# ADA Curb Ramp New Construction Inspection Form (Perpendicular)

Nw 287

24952.54

Nw mays

## PERPENDICULAR RAMP (PR)

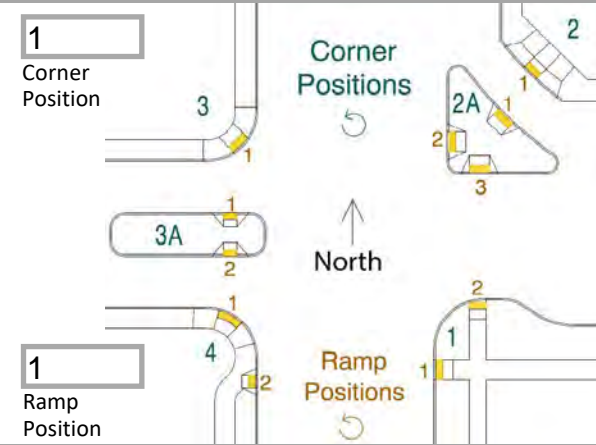
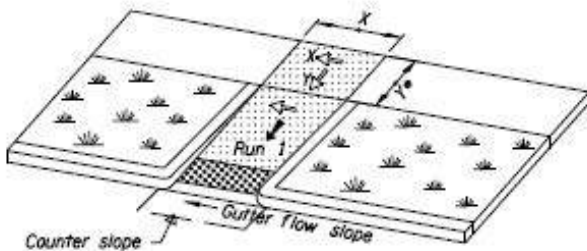
ICRR RR1 fail
